CONFERENCE SYSTEM INFRARED CONFERENCE SYSTEM

TS-910 SERIES TS-800 SERIES

PRECAUTIONS FOR USE OF THE INFRARED CONFERENCE UNIT

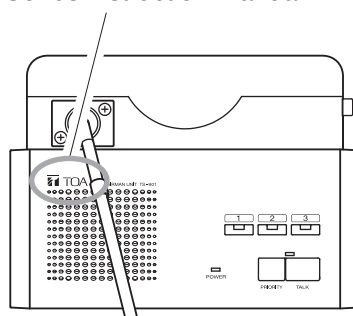
1. Identifying Units Based on TOA Logo Position

[If the TOA logo is located on the right]

TS-910/800 Series instruction manual descriptions are not applicable in terms of the operations described in the following sections.

[If the TOA logo is located on the left]

Please use the unit as described in the TS-910/800 Series instruction manual.
